M110 (114-00-0139)

NATURE AND REASON FOR CHANGE Change R29 from 470Ω 1W to

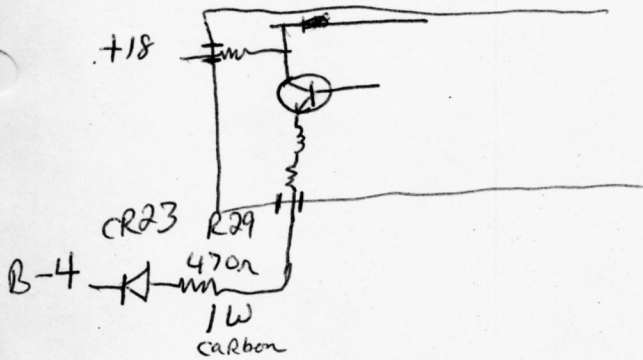
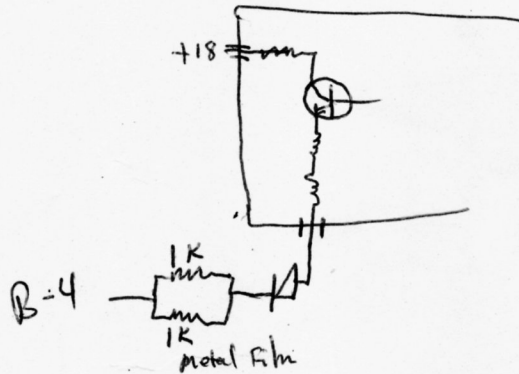
② 1K Res in parallel and change location of B-4 switching Diode & Res. to keep Resistor away from case. Tank - Reduced Drift in 5 min period ~~from~~ about 750KΩ to 150KΩ

Change to
